# **Il Villaggio Toscano Project**

## **Final EIR Supplemental Responses to Comments**

**March 2013**

**Figure 1**  
Section Illustrating Building Heights

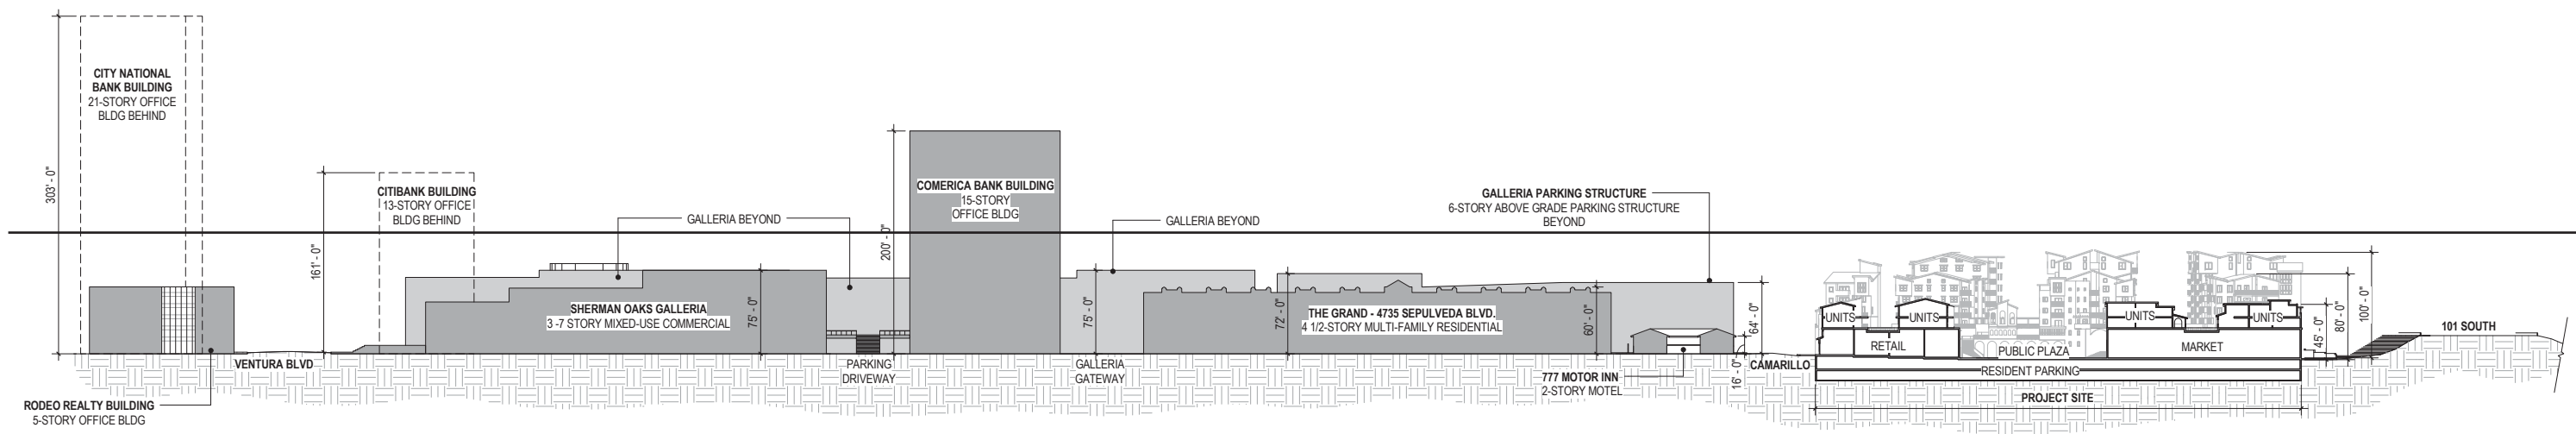
The EIR fails to provide substantial evidence to support its conclusion that the Project will have no significant impact on aesthetics. To the contrary, the analysis is misleading and deceptive, obfuscating the true significant impacts of the Project.

In order to provide any meaningful analysis, one needs to look elsewhere in the EIR, where the Project is described as a six-story building on top of a two-level parking podium. This is the functional equivalent of an eight-story building.

The environmental documentation must provide consistency in description in order to provide the ability for meaningful comparison. Currently, that has been denied to the decisionmakers and the public. When so done, proper comparison reveals a Project that is as much as four times taller than the two-story motel directly across Camarillo on Sepulveda, and 60% taller than the Grand Apartments,<sup>1</sup> as much as 60% taller than the parking garage, and as much as eight times as tall as the residential buildings and homes across Sepulveda. Under no circumstances can the Project be considered “only marginally taller” than the adjacent and nearby buildings to the south. To so claim, as the EIR does, borders on fiction, and shows a fundamental dishonesty that mars the EIR. The Project height and massing would dramatically alter the existing visual character of the area. Moreover, Sepulveda Boulevard will not serve as a “buffer” sufficient to mitigate the significant aesthetic impacts. Further, the “buffer” concept, whatever that is intended to mean, is vague, ambiguous and unsupported in the EIR.

Describing the heights of surrounding buildings in terms of stories is an appropriate methodology to use for establishing the baseline conditions for the EIR's aesthetics analysis. Stories provide an easily identifiable metric for the public. In addition, building height information for the existing buildings in the project area is also communicated via Figures IV.A-1 through IV.A-3 of the Draft EIR, which provide photographs of the surrounding project area.

As shown in Figure 1 on page 7, the proposed building heights are consistent with building heights along Sepulveda Boulevard in the project vicinity. These nearby buildings range in height from approximately 16 to 200 feet. In addition, The Grand Residential Building south of the project site is approximately 60 feet in height and the Galleria Parking Garage immediately south of the project site is approximately 75 feet in height with appurtenances permitted extending up to 95 feet. Proposed building heights would range from 45 to a maximum of 100 feet in height. Thus, as stated in the EIR and shown in Figure 1, some of the proposed buildings would be shorter than, while other parts would be taller than, The Grand Residential Building and the Galleria Parking Garage, and the project's buildings overall would visually blend into the surrounding locale.

In considering existing building heights in the area it is critical to also recognize the role that Sepulveda Boulevard plays in terms of creating a physical separation between the project site and buildings located on the east side of Sepulveda Boulevard. The recognition that roadways create substantial separations and barriers is reflected in the City's CEQA Thresholds Guide.<sup>1</sup> Designated a major highway, Sepulveda Boulevard has a sidewalk-to-sidewalk width of approximately 100 feet in the project area. This distance clearly provides a substantial and meaningful separation (i.e., buffer) between the project
